CITY OF VALDEZ Project Title: New Well 5 Pumping Station Project No.: 21-310-2538 Contract No.: 2406

SUBJECT: Addendum No.4

VALDEZ WELL 5 QUESTIONS AND ANSWERS – OCTOBER 27, 2025

RETAINING WALL DETAIL

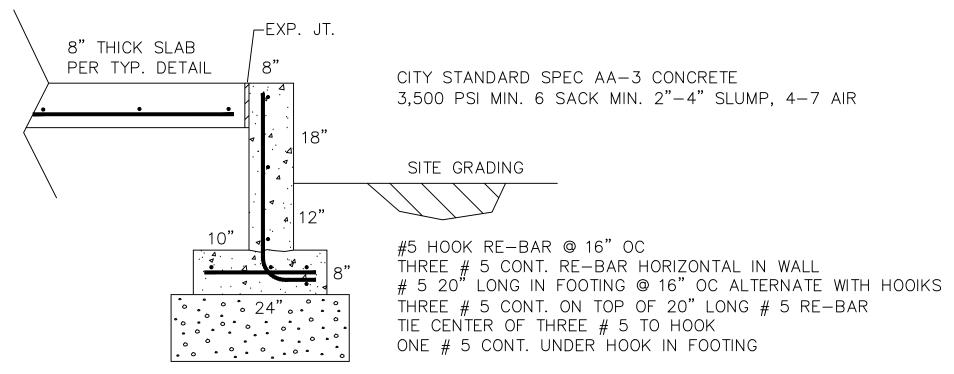
13. **Question:** Is there any further information about the load bank vault? Does it have a foundation or stem wall or is it just placed on grade?

Answer: See attached foundation detail for retaining wall.
